Request:  
Compatibility Review  
of The Cottages at  
Pine Ridge, a 13-lot  
single family  
subdivision.

Hudson Planning Commission	COMPATIBILITY REVIEW – THE COTTAGES AT PINE RIDGE
Case No. 2023-555	August 14, 2023

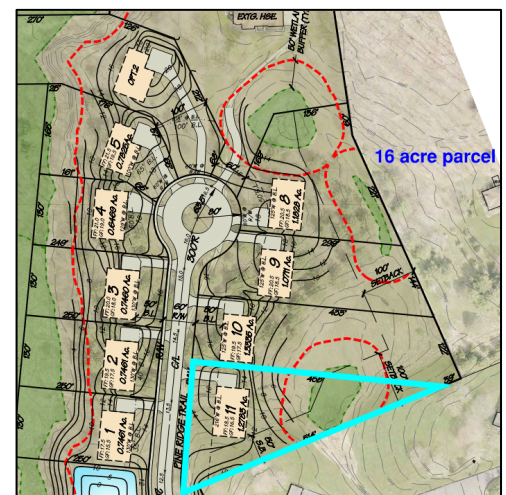
7. **Open Space:** The applicant has indicated 68%, or 49 acres, of the total project site would be dedicated open space.
8. **Tree Protection:** The preliminary subdivision plan will require a tree and vegetation plan to identify existing trees of six-inch caliper or larger. Staff has identified the following areas in need of further study, in consultation with the City Arborist, as identified on the following figure:

- a. **Area A:** Staff notes an alternate home location for subplot #6 has been identified at this location. This alternate location would require significant tree clearing and wetland impacts. Staff recommends siting this home near the cul-de-sac.

- b. **Area B:** Question if this area could be preserved based on its location at the property boundary and within the 100’ setback to a structure.
  - c. **Area C:** Staff notes two homes would be proposed at this location; however, tree clearing has not been included in the submitted plan. Staff recommends tree clearing be kept at a minimum to accommodate the two proposed homes. Of note, the properties would be subject to a 100’ landscape setback.

- d. **Area D:** Tree clearing is proposed at this location to construct a stormwater pond and street. Question if the proposed clearing could be reduced near W. Streetsboro Street.

6. Tree Protection: Further study the areas identified as Areas A, B, C, and D in this staff report to minimize tree clearing.
  7. Wetland Protection: Revise grading to be located outside of wetland setbacks at sublots #1-5, #7-8, and #11. Grading impacts associated with stormwater basins shall be minimized with native plantings incorporated.
